Access Compliance Report Public Rights-of-Way (Curb Ramps)

Main Street: SILVER_FOX_RD Cross Street: HILLROSE_DR Location: NE

ADA ID: RPRK211206172212 Ramp Type: Type 1 - Perpendicular Diagonal Initial Pass/Fail: Pass Overall Compliance: No Severity Score: 10

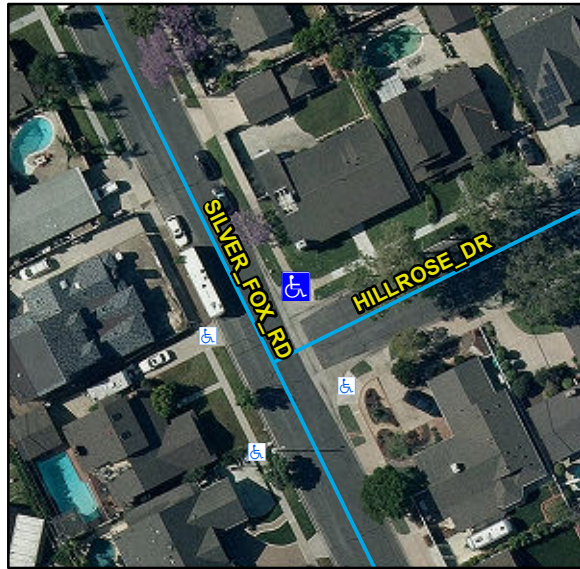
R204.3, R305, R304.5.3, STD 1115

Compliance	Description	Data	Compliance	Description	Data
N/A	Ramp Length (in)	80	N/A	Flare Type LT	
Yes	Ramp Width (in)	54			Sloped
Yes	Ramp Run Slope (%)	5.9	N/A	Flare Slope LT (%)	3
Yes	Ramp Cross Slope (%)	1.8	N/A	Flare Traversable LT	No
N/A	Landing Present	Yes	N/A	Flare Type RT	
N/A	Landing Length (in)	52			Sloped
Yes	Landing Width (in)	54	N/A	Flare Slope RT (%)	6
Yes	Landing Run Slope (%)	1.1	N/A	Flare Traversable RT	No
Yes	Landing Cross Slope (%)	1.4	No	DWS Provided	No
N/A	Landing Movement Obstructed?	No	N/A	DWS Contrast	N/A
	Landing Movement Type	N/A	N/A	DWS Length (in)	N/A
N/A	Landing Shared	No	N/A	DWS Full Width	N/A
N/A	Clear Space	Yes	N/A	DWS Offset Left (in)	N/A
N/A	Clear Space To Crosswalk (in)	48	N/A	DWS Offset Right (in)	N/A
N/A	Marked Crosswalk 1	No	N/A	Marked Crosswalk 2	No
	Crossing 1 Direction	W		Crossing 2 Direction	S
	Marked Crosswalk 1 Width (in)	N/A		Marked Crosswalk 2 Width (in)	N/A
N/A	Ramp Inside Crosswalk 1	N/A	Yes	Ramp Inside Crosswalk 2	N/A

Crossing 1 Slope (%)	8.3		Crossing 2 Slope (%)	3.4
	Crossing 1 Cross Slope (%)	2.4		Crossing 2 Cross Slope (%)	2.4
Yes	Gutter Ponding	No	Yes	Curb Slope	3.7
Yes	Gutter Lip Height (in)	0		Road Run Slope (%)	2.4
Yes	Gutter Run Slope (%)	1.2		Road Cross Slope (%)	2.6
No	Gutter Cross Slope (%)	2.5			
Yes	Overall Surface Condition: Acceptable		No	Perp Joint Present	No
	Cross Gutter Present?	Yes		Spandrel Present?	Yes
	Replace Cross Gutter?	No		Replace Spandrel?	No

Remove & Replace Curb Ramp With Two New Directional Ramps or Equivalent. Remove & Replace Gutter.
